Product Change Notification

PCN-AI-7494-2021

Due to quality improvements, the hardware of the items listed is being changed.

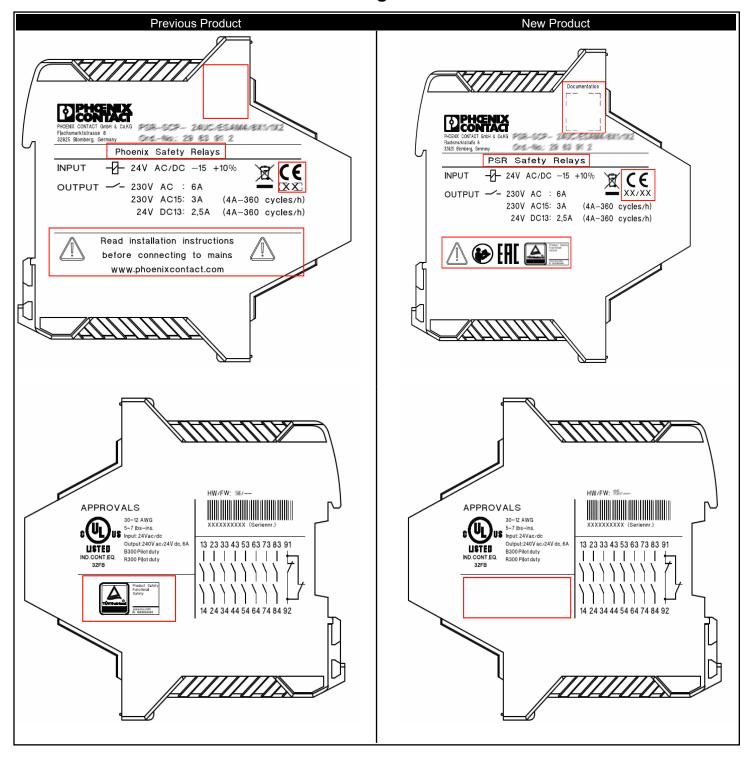
In addition to the year of manufacture, the calendar week will also be displayed below the CE mark. The various pictograms and TÜV approvals will be displayed in the lower area on the left half of the housing; the plug will no longer be coded.
